Continuous Quality Improvement Improved Material for Retainer Tubes (now Green) to Insert Suction Rods

- Dialog+ SW 7.xx/8.xx
- Dialog+ SW 9.xx

FSI_2014_02_DialogP_Green Retainer Tubes_EN.doc/pdf

Fig.: Green retainer tubes A

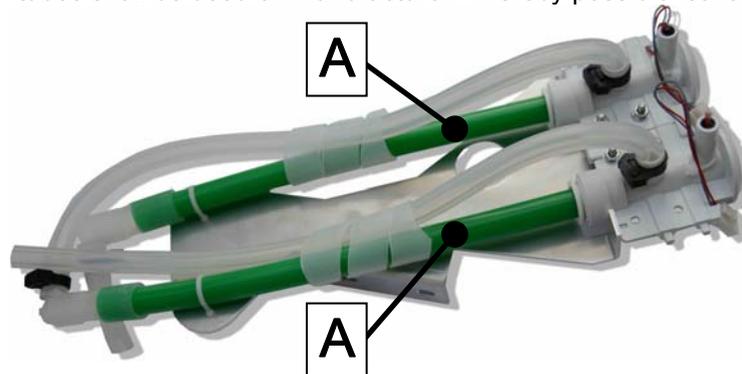
Within our continuous quality improvement process the blue retainer tubes used to insert the suction rods were modified. The new green tube material **A** has improved working pressure and temperature parameters. As of August 2014 the new green retainer tubes shall be used ex manufacturer. Thereby possible leakages are prevented.

Exchange the blue retainer tubes to the green retainer tubes during the next service job, latest during the next technical safety inspection. Check your inventory and retrofit all retainer tubes. Pay attention to the affected machines/serial numbers in the table:
